1997 - 2002 Corvette: Service Bulletin: SMU - Revised Side Cover and Gasket Replacement (RH)/Differential Carrier Cover and Seal Replacement

Number: 02-04-20-003

Subject: SMU - Revised Side Cover and Gasket Replacement (RH)/Differential Carrier Cover and Seal Replacement - Right

Model Year: 1997-2002 Chevrolet Corvette

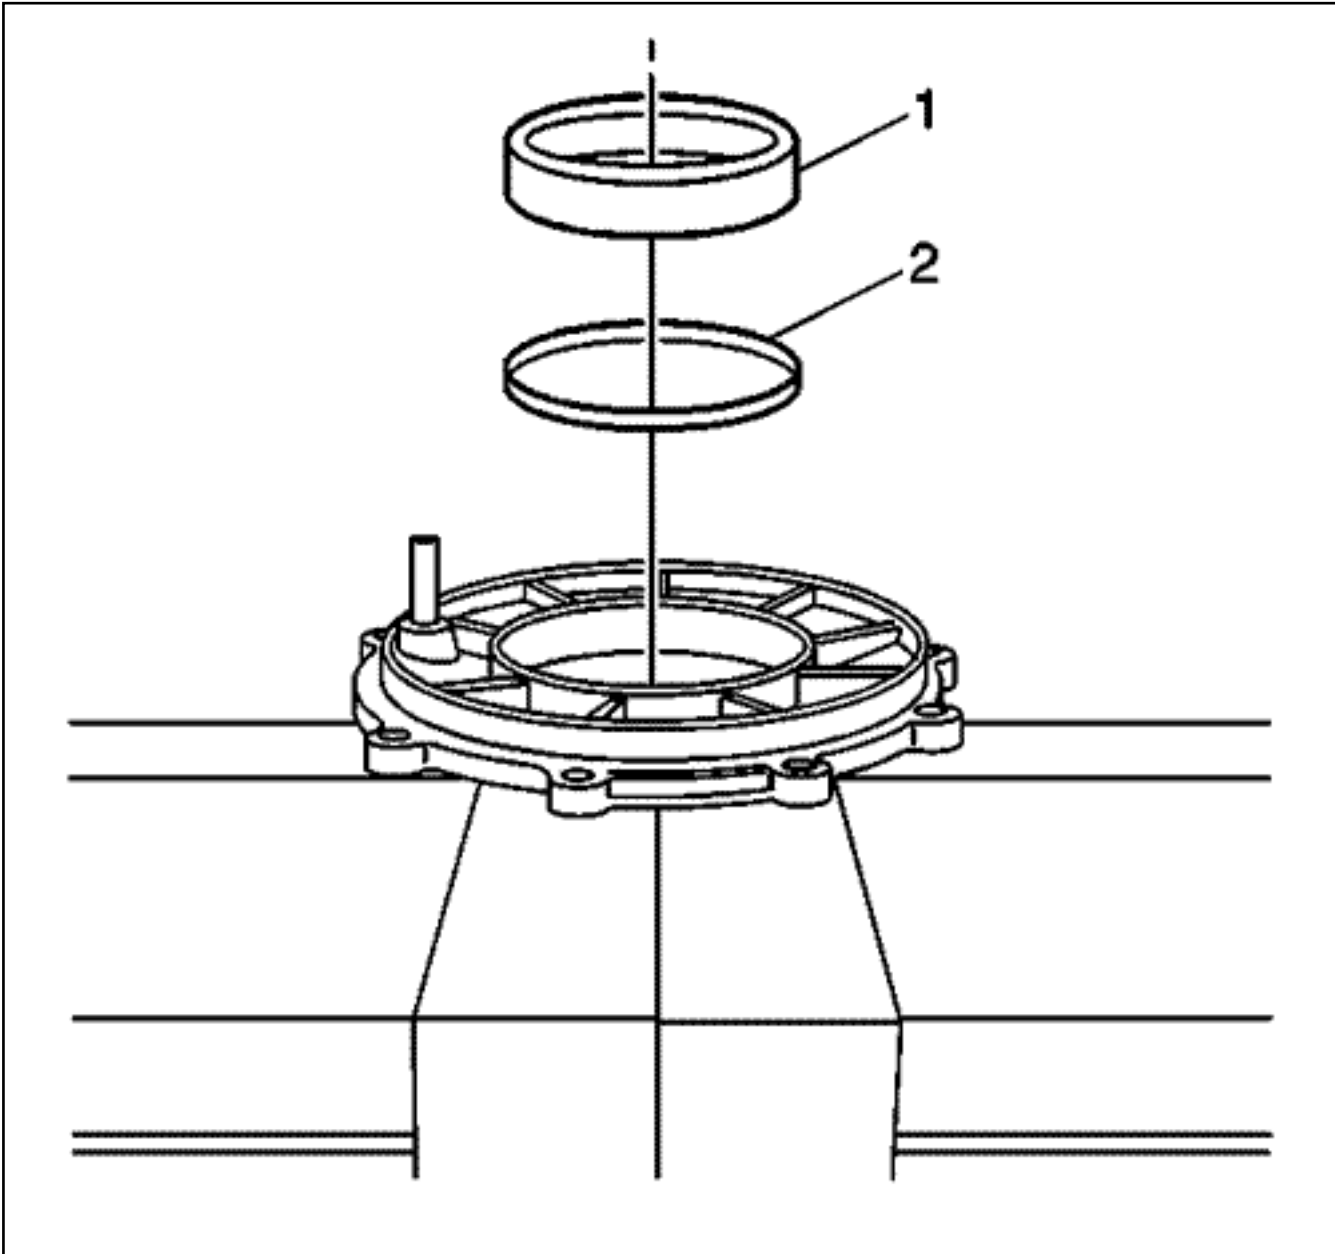
Whenever service requires the replacement of the right side differential cover, the covers MUST be measured and the right side shim pack adjusted to compensate for machining tolerances between the two components. Failure to perform this measurement procedure may result in improper differential bearing preload.

13. Use a caliper (2), a straight edge (1), and J 42168-16 (3) in order to measure the NEW differential cover bore dimension. Record the measurement as value A.
14. Use a caliper (2), a straight edge (1), and J 42168-16 (3) in order to measure the old differential cover bore dimension. Record the measurement as value B.
15. Subtract value B from value A. If the computation is a positive value, add shims equal to the value, to the existing shim pack. If the computation is a negative value, subtract shims equal to the value, from the existing shim pack.
